ADDENDUM NO. 1 TO PROJECT NO. 44185

CONSTRUCTION WORK, HVAC WORK AND ELECTRICAL WORK

**PROVIDE VENTILATION, MAIN SCHOOL BUILDING
VARIOUS DOCCS FACILITIES**

March 8, 2013

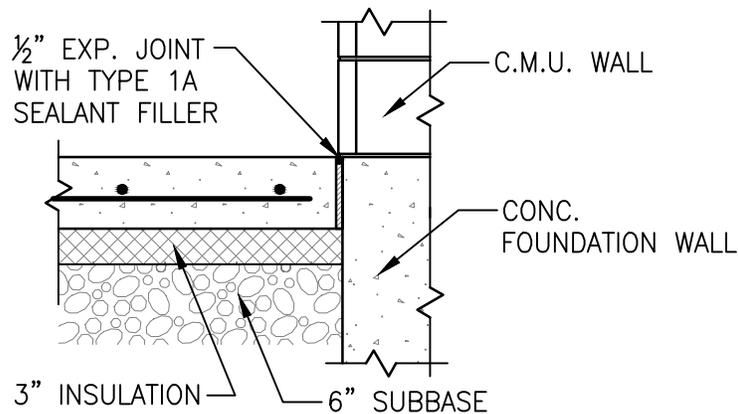
5. Drawing S-201:
 - a. SECTION 2/S201: Change “1/2” EXP. JOINT WITH TYPE 1B SEALANT” to read “1/2” EXP. JOINT WITH TYPE 1A SEALANT.”
 - b. Replace detail “TYP. MASONRY WALL REINFORCEMENT ELEVATION” with the detail shown on drawing S-202 accompanying this Addendum.
 - c. Add detail “TYPICAL SLAB WALL EXPANSION JOINT” shown on drawing S-202 accompanying this Addendum.

TYP. MASONRY WALL REINFORCEMENT ELEVATION

TYPICAL SLAB WALL EXPANSION JOINT

DWG NO:
 E-110

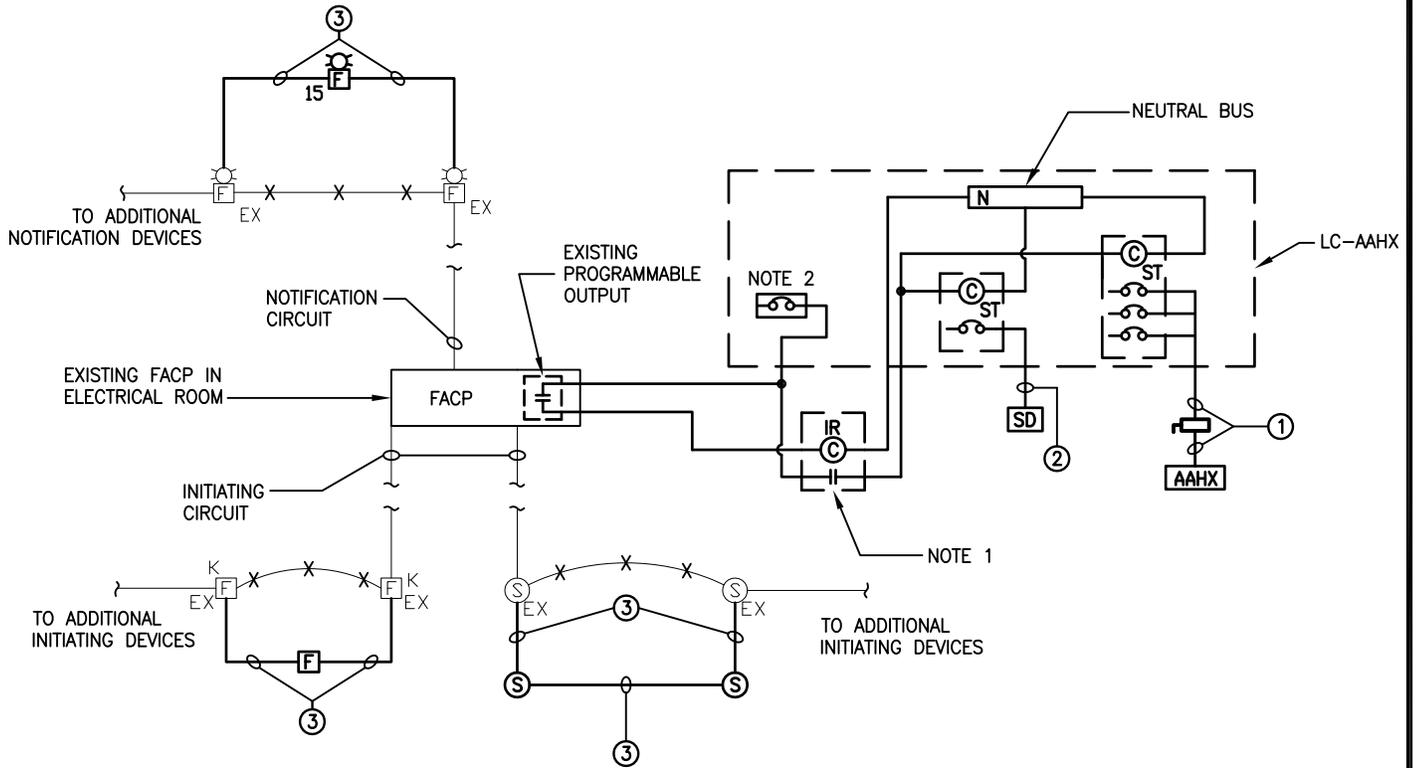
- a. “FIRE ALARM – CAYUGA CF BLDG. NO. 4”
 - Add leader, with text to read “NOTE 4 (TYP)”, to one symbol for AIR DUCT SMOKE SENSORS.
- b. “FIRE ALARM – CAYUGA CF BLDG. NO. 4”
 - Remove symbol for Individual Addressable Module, IAM.
- c. “FIRE ALARM ONE-LINE – CAYUGA CF BLDG. NO. 4”
 - Replace detail with detail on drawing E-110, noted “REVISED DETAIL FIRE ALARM ONE-LINE 3/6/2013”.

- a. “FIRE ALARM – MARCY CF BLDG. NO. 4”
 - Add leader, with text to read “NOTE 4 (TYP)”, to one symbol for AIR DUCT SMOKE SENSORS.
- b. “FIRE ALARM – MARCY CF BLDG. NO. 4”
 - Remove symbol for Individual Addressable Module, IAM.
- c. “FIRE ALARM ONE-LINE – MARCY CF BLDG. NO. 4”
 - Replace detail with detail on drawing E-110, noted “REVISED DETAIL FIRE ALARM ONE-LINE 3/6/2013”.

- a. “FIRE ALARM – MARCY CF BLDG. NO. 26”
 - Add leader, with text to read “NOTE 4 (TYP)”, to one symbol for AIR DUCT SMOKE SENSORS.
- b. “FIRE ALARM – MARCY CF BLDG. NO. 26”
 - Remove symbol for Individual Addressable Module, IAM.
- c. “FIRE ALARM ONE-LINE – MARCY CF BLDG. NO. 26”
 - Replace detail with detail on drawing E-110, noted “REVISED DETAIL FIRE ALARM ONE-LINE 3/6/2013”.
